**ZONING SITE PLAN  
ART FRAME EXPANSION**  
LAND LOT 47, DISTRICT 18, 2ND SECTION  
516 VETERANS MEMORIAL HIGHWAY SE  
COBB COUNTY, GEORGIA

**PETITION NO:** Z-59

**ZONING COMMENTS:**

## STAFF RECOMMENDATIONS

Drawing No. **C2.0**

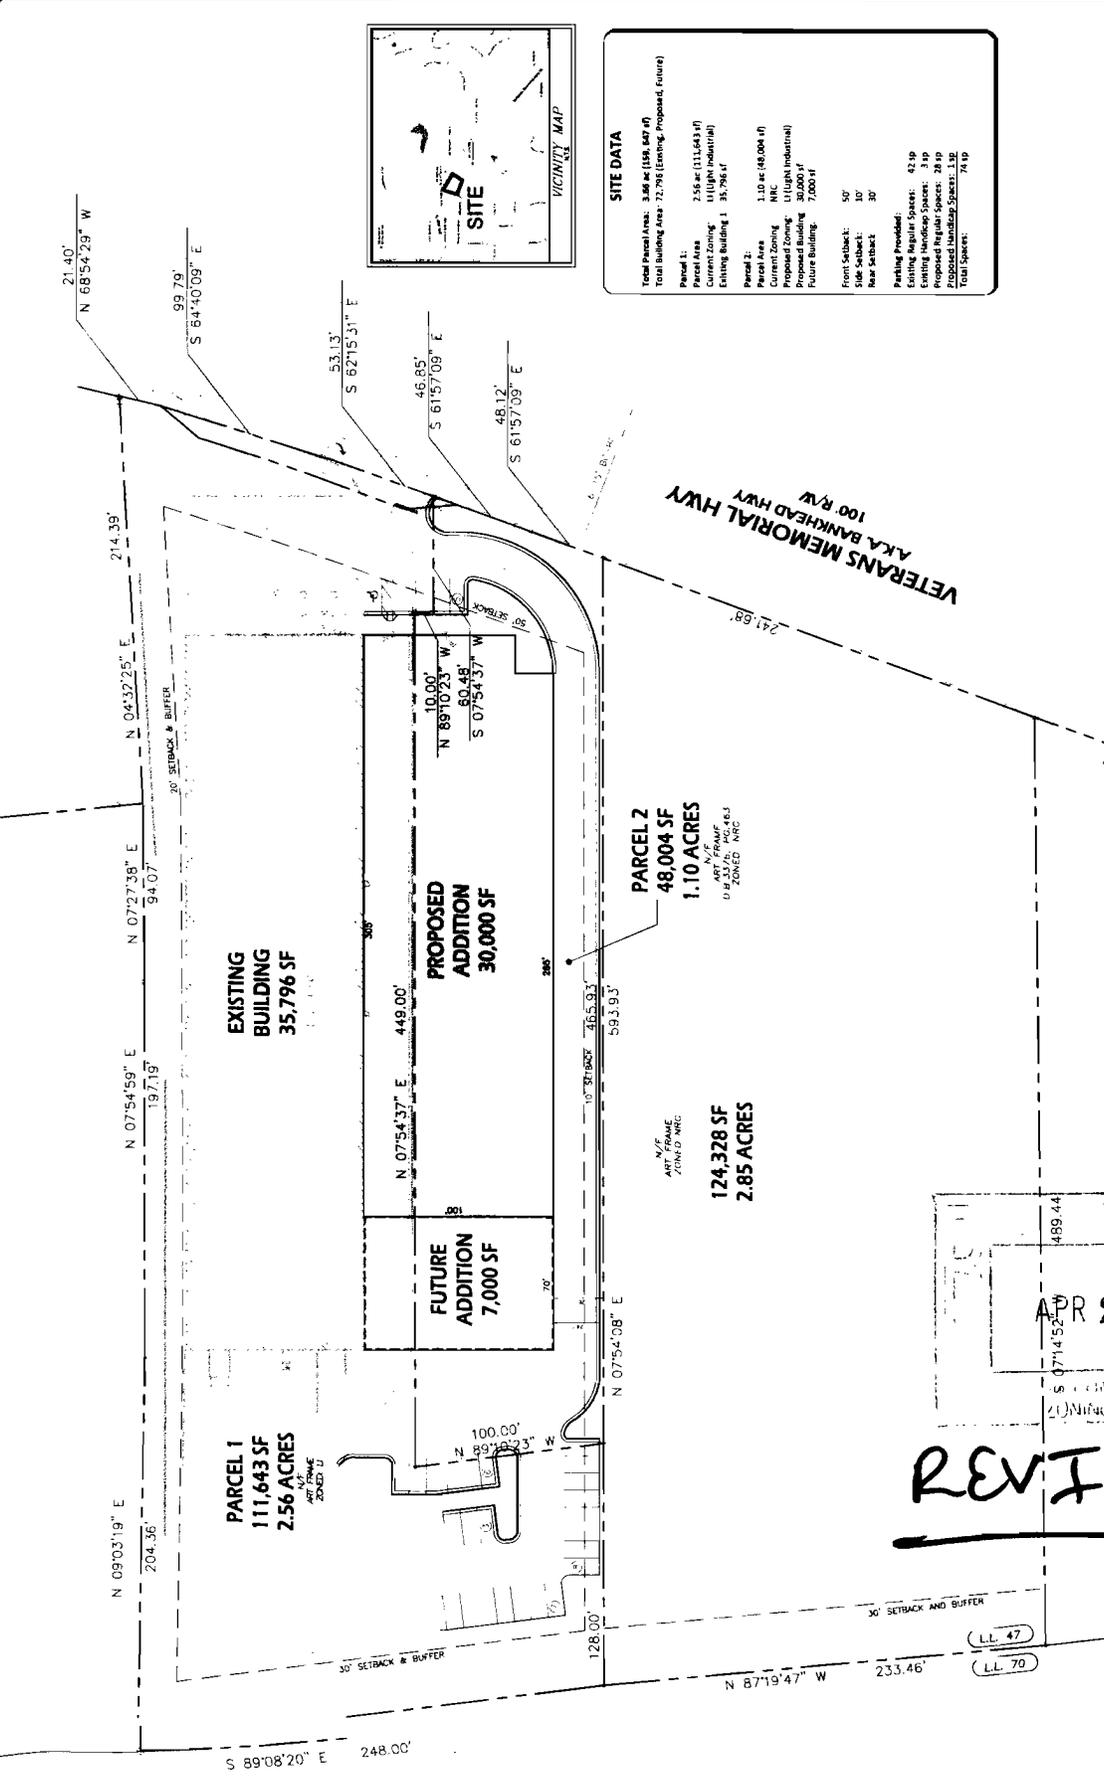
Project engineer must evaluate the impact of increased volume of runoff generated by the proposed expansion of the site on the existing detention pond and downstream receiving system.

- Provide comprehensive hydrology/stormwater controls to include development of out parcels.
- Submit all proposed site improvements to Plan Review.
- Any **spring activity** uncovered must be addressed by a qualified geotechnical engineer (PE).
- Structural fill \_\_\_\_\_ must be placed under the direction of a qualified registered Georgia geotechnical engineer (PE).
- Existing facility.
- Project must comply with the Water Quality requirements of the CWA-NPDES-NPS Permit and County Water Quality Ordinance.
- Water Quality/Quantity contributions of the existing lake/pond on site must be continued as baseline conditions into proposed project.
- Calculate and provide % impervious of project site.
- Revisit design; reduce pavement area to reduce runoff and pollution.

- No Stormwater controls shown \_\_\_\_\_
- Copy of survey is not current – Additional comments may be forthcoming when current site conditions are exposed.
- No site improvements showing on exhibit.

1. Applicant must verify that adequate stormwater management is provided within the existing master detention facility or redesign to accommodate the proposed site expansion.

Recommend sidewalk along the Veterans Memorial Highway frontage.

Recommend no additional access to Veterans Memorial Highway.

- Based on the above analysis, Staff recommends **APPROVAL** subject to the following conditions:
- Revised site plan received by the Zoning Division on April 23, 2015 with District Commissioner approving minor modifications;
